## PRODUCT/PROCESS CHANGE NOTICE (PCN)

PCN #: **L-0405-04** DATE: 5/19/2004  
Product Affected: VFQFP (NL/NLG28/40/52/56/68)  
packages shipped in Tape and Reel

### ATTACHMENT - PCN #: L-0405-04

FROM:

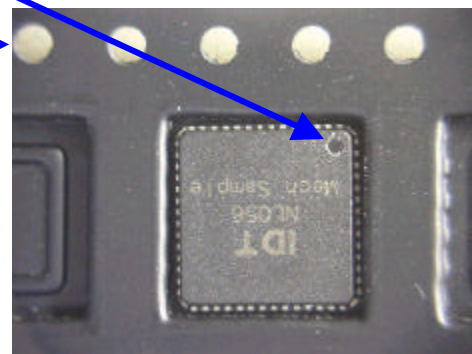
**PCN Type:** To comply to current EIA Standards (EIA-481-B) requirement.  
**Data Sheet Change:** No  
**Detail of Change:** This change will be implemented on all VFQFP packages.

Electrical Pin 1

TO:

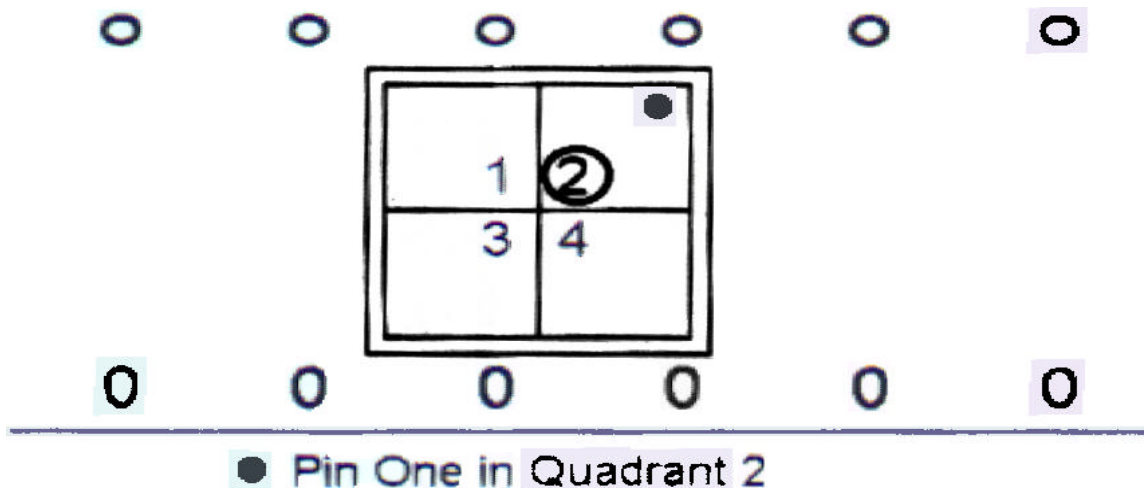
Round  
Sprocket  
Holes

Additional label will be placed on the intermediate box (pizza box), reel and ESD/moisture barrier bag to alert customer of this change.
